September 13, 2017

Subject: Response to May 2017 Site Investigation Report
Troy Laundry & Cleaners, 320 Pine St., Sheboygan Falls, Sheboygan County, WI
DNR BRRTS Activity #: 02-60-385641

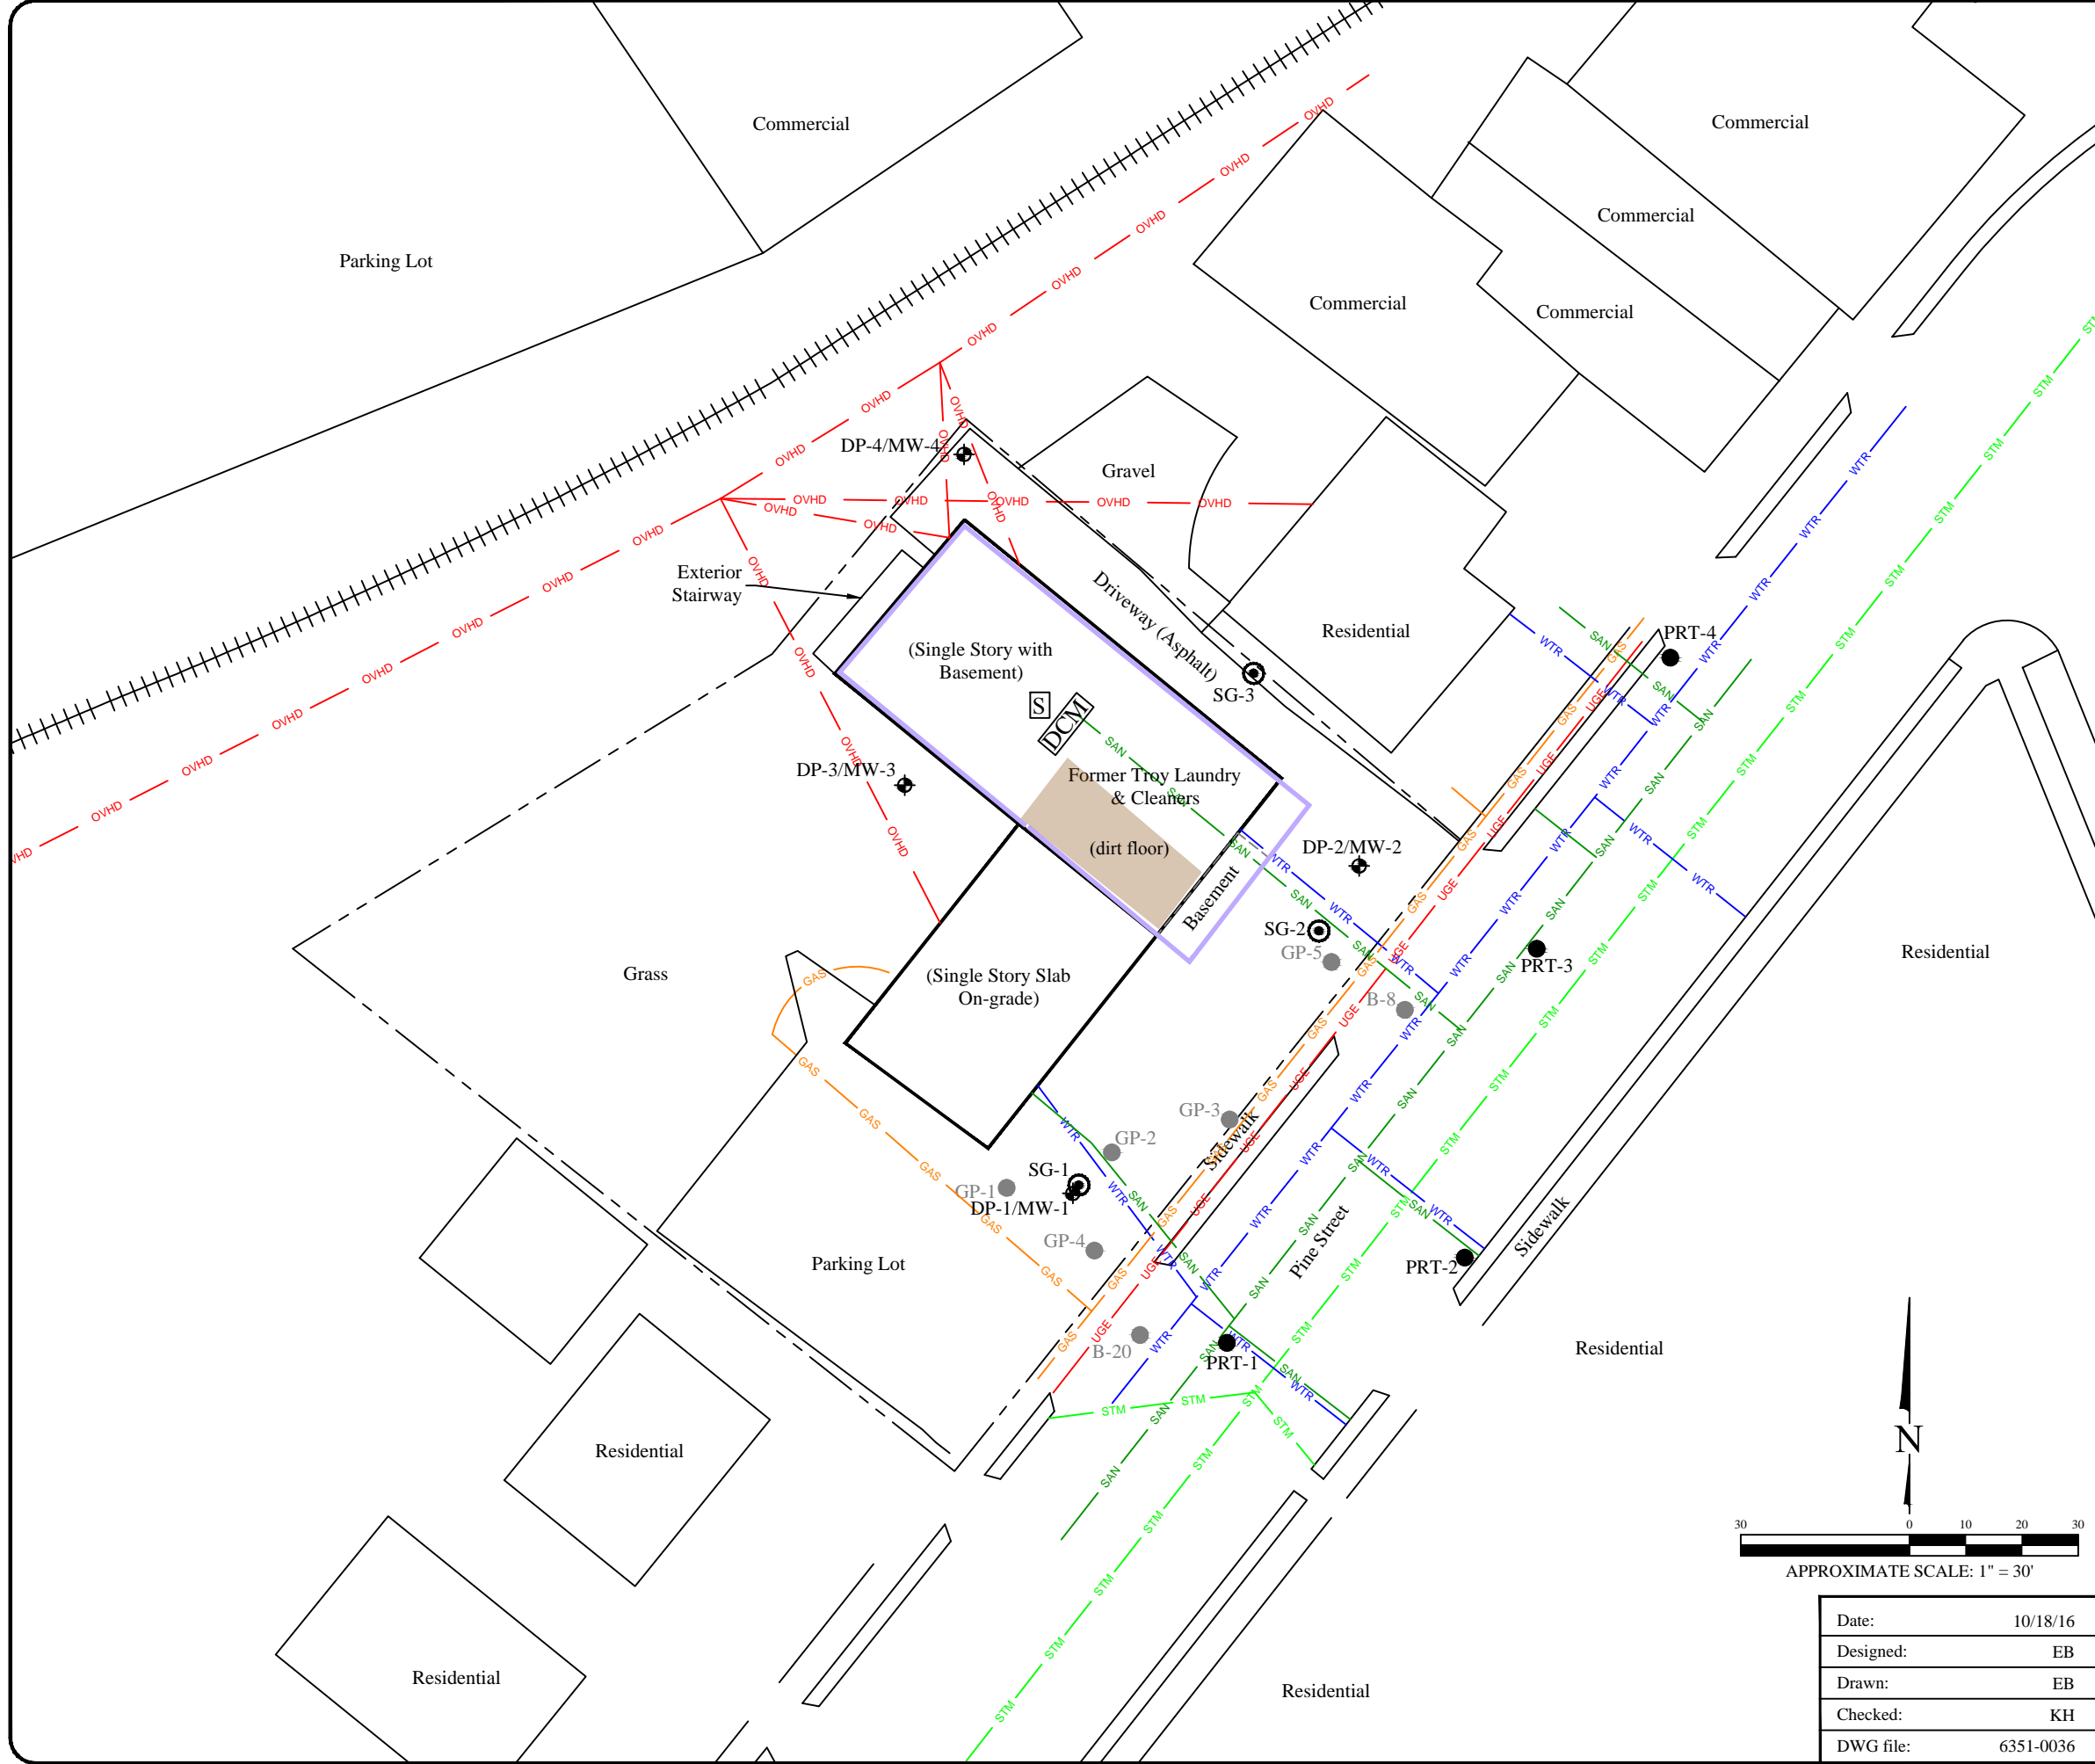
1. Tetrachloroethylene ("PCE") contamination in groundwater identified in grab samples collected from borings GP-5 and B-8 (see attached Figure 2 – Site Layout) have not been verified or collected from a monitoring well that was constructed in accordance with ch. NR 141, Wis. Adm. Code as required under s. NR 726.05(7)(c), Wis. Adm. Code. An additional monitoring well needs to be installed in the vicinity of boring GP-5 to assess contamination concentrations and trends near the source area. Based on the groundwater analytical results obtained from this monitoring well, additional monitoring points maybe required to define the extent of groundwater contamination to the southeast and/or along utility lines.

5. It appears that soil borings SB-1 through SB-4 were inadvertently identified as DP-1 through DP-4 on the figures. Please revise on future site maps so there is consistency throughout the document.

7. The property boundaries as shown on the figures included in the May 2017 SIR do not match what is listed on the Sheboygan County Land Information website. The Sheboygan County Land Information website lists the main building with the basement (Parcel # 59282907080) as 320 Pine Street and the slab-on-grade portion of the building (Parcel # 59282907070) as 326 Pine Street. This is important information that is needed at the time of closure in order to provide proper notifications and continuing obligations for each parcel. This needs to be clarified in the text and figures of future submittals.

- Is there a sump in the basement and where does it discharge? Does the building contain any floor drains? Can these items be added to the Site Layout drawing?

- Do we know where the location of the dumpsters where spent filters may have been thrown in? I see that PCE storage is marked with an “S” on the Site Layout drawing. Is there additional information with regard to storage and/or management of hazardous materials on the property?
- Are there any storm sewers onsite? If so can those be added to the drawing.

- Is there a sump in the basement and where does it discharge? *There is a sump pit but no pump and the owner has no recollection of pump ever being used.* Does the building contain any floor drains? *No, there is not any indirect connection to main floor plumbing and the subsurface.* Can these items be added to the Site Layout drawing? *No Floor drains are present. The sanitary line is above basement floor grade, i.e., you can physically touch the line and is shown on the attached figure.*

- Are there any storm sewers onsite? If so can those be added to the drawing. *No storm sewers, surface runoff is handled by sheet flow to curb storm grates. Shown on figure.*
